REMARKS

Reconsideration of the above-identified patent application, as amended, is respectfully requested. The present amendment is responsive to the Office Action mailed February 6, 2003. A petition for an extension of time in which to respond to the Office Action accompanies this amendment.

Fig.1 *PRIOR ART*

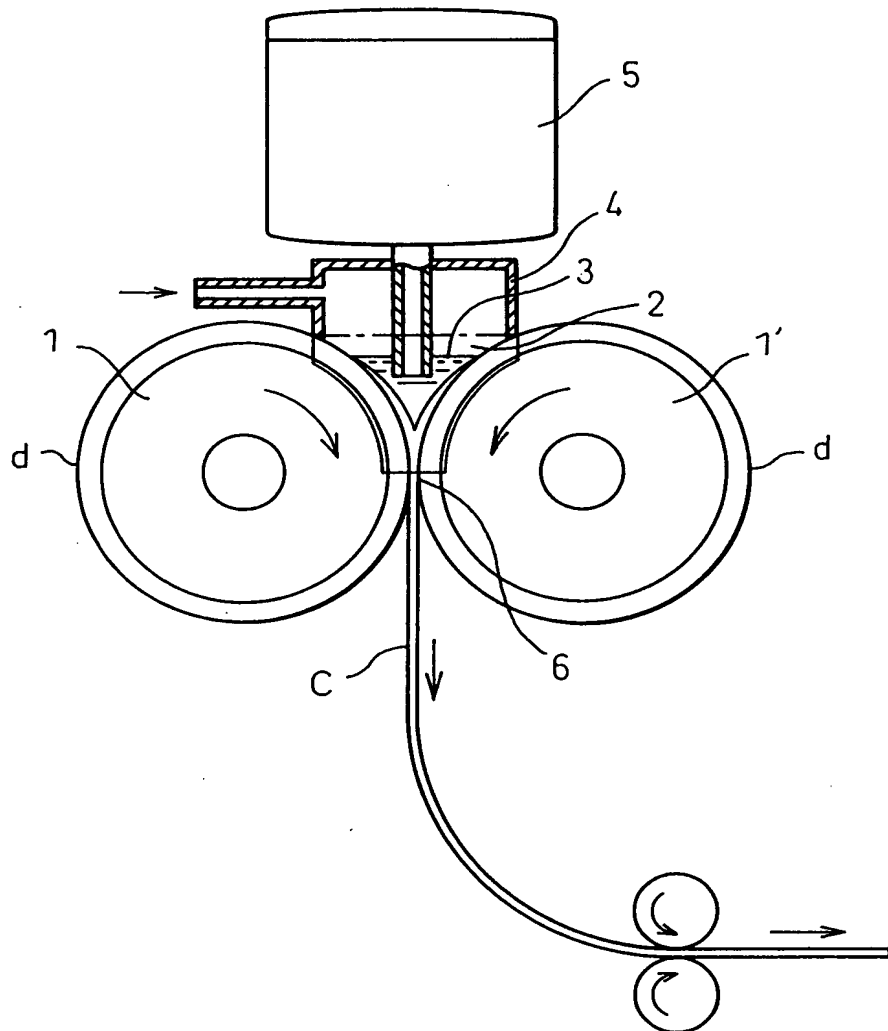
In response to the objection to Fig. 1, enclosed is a sketch of a proposed amended Fig. 1 marked in red wherein Fig. 1 is designated by the legend --Prior Art--.

Fig. 24

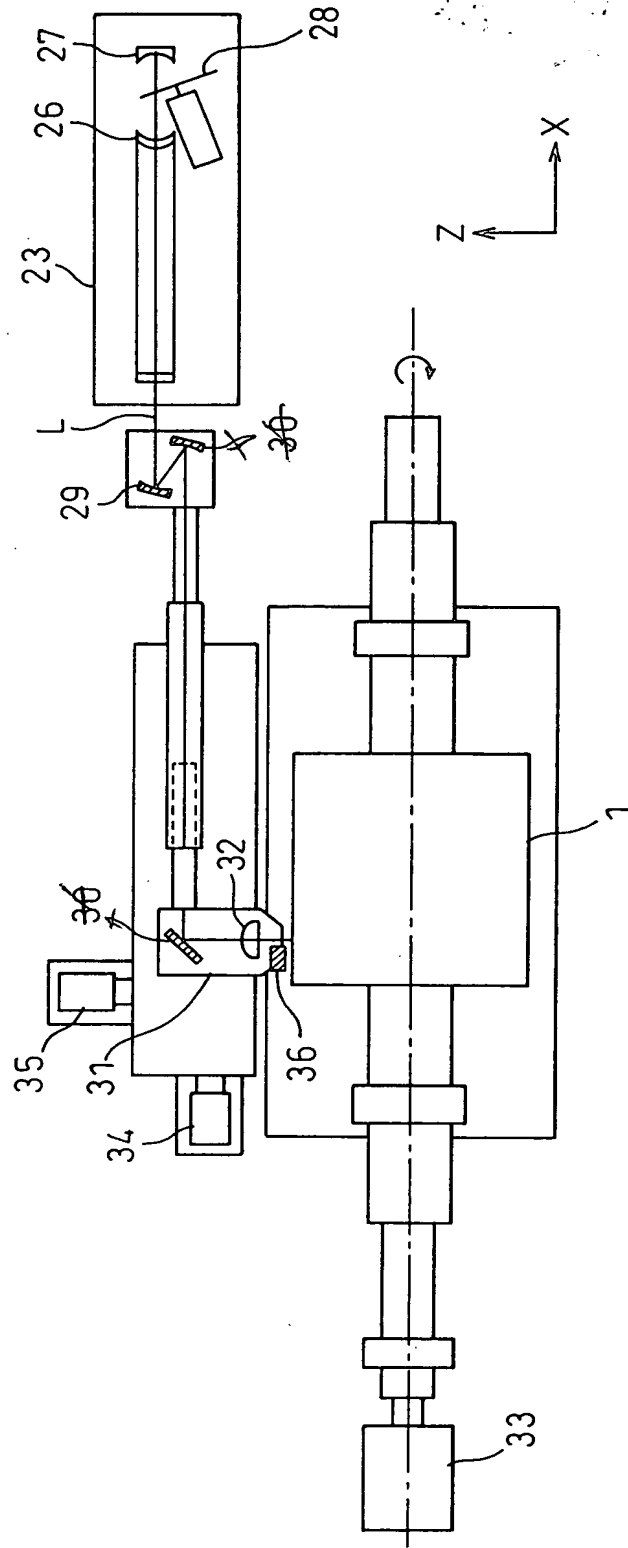
Fig. 34 was objected to in the Office Action. There is no Fig. 34 in the application. The applicants believe that the Office Action is actually objecting to Fig. 24.

In response to the assumed objection to Fig. 24, enclosed is a sketch of a proposed amended Fig. 24 marked in red wherein item "30" has been deleted from Fig. 24.
